I have made remarks page by page on your last 44 page comments. It appears the main problem was wording in our draft. Your last comments do not really bring new qualitative or important information, but rather more details on what you previously wrote, hence the needed changes had been performed in the draft. As already said you proposed several interpretations that could be interesting; but for which more experimental confirmation are needed, hence our review did not rely on them. This mainly resulted in non considering your activity coefficients, which is quite a minor problem since for the system under discussion (Np(V) carbonate solubility product) the main goal of our review is to provide stoichiometries and equilibrium constants. The main subjects I commented are the following:

Page 2
1. Comments on the experimental studies of Neck and Runde

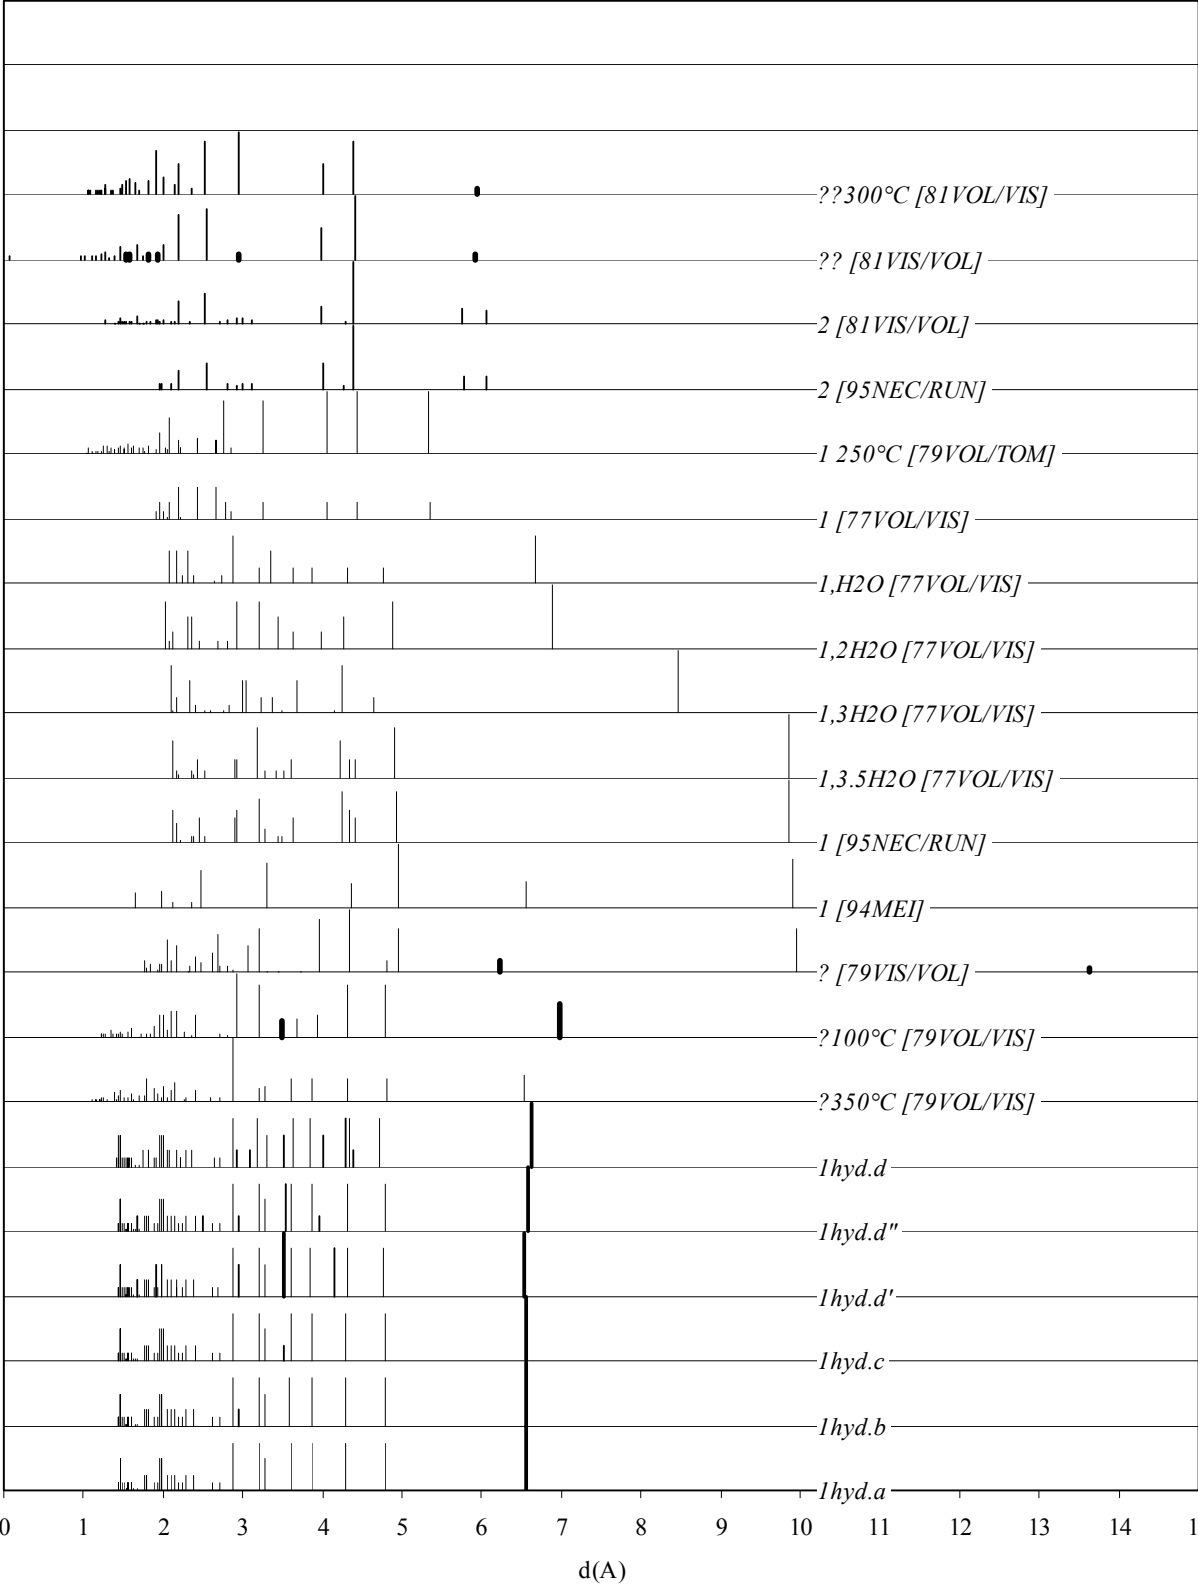
Problems in solid phase is discussed or suspected for all the published studies and supported by experimental results: x-ray diffraction patterns (see the figure) and kinetic observations. Your study is not used to discuss these problems, just because you only paid attention to obtain a stable reproducible solid phase, and not to discuss its ripening and evolution, hence you provided fewer information than in other studies : nothing is wrong with this. I still do not know whether you performed x-ray diffraction before solubility equilibration, or after (from your publications it rather seems it was characterisation of the phase initially used for solubility measurements).

This comment is one of the aspect already discussed (see PV 2c): there are less experimental information and discussion on solid phase characterisation and evolution in your published solubility works, than in the studies used in our review to discuss solid phase formation.

PV 27b

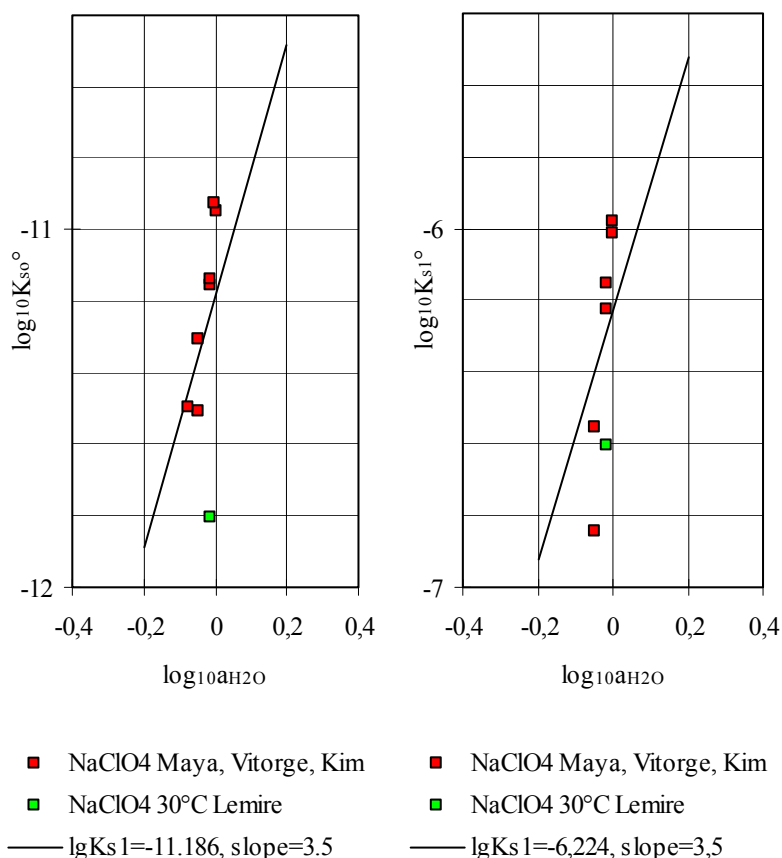
The x-ray diffraction patterns published in [77VOL/VIS] and [95NEC/RUN] are the same, but I do not know whether they correspond to samples prior or after the achievement of equilibrium solubility

X-ray spectra published by Meinrath can be interpreted with a mixture of the solid phase you prepared (or obtained after solubility equilibration?), and the one I obtained after solubility equilibration. (see the figure referred in PV 2c)
